Power Genius XL™ Release Notes – Version 3.8.8

March 27, 2024

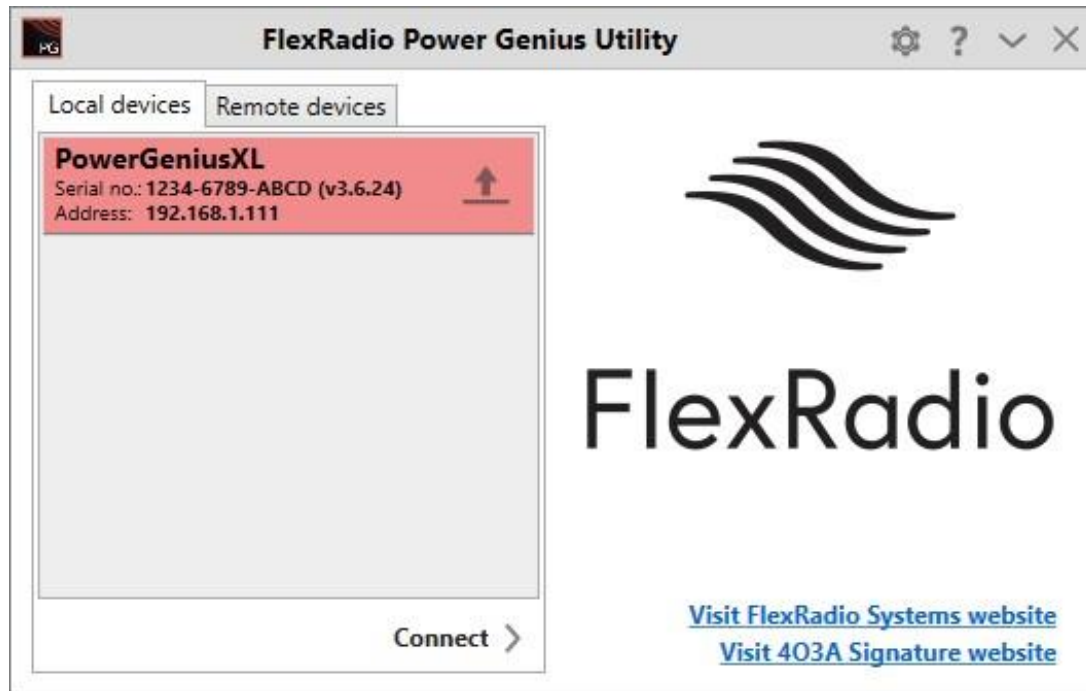
Unified Windows Utility and PGXL Firmware Releases – You must install the Power Genius Utility v3.8.4 to upgrade the firmware in the Power Genius XL amplifier. After starting the updated PGXL Utility, if the program finds that the firmware installed in the amplifier is out of date a screen like the following will be shown. When selected, the firmware upgrade dialog box is displayed to start the firmware update.
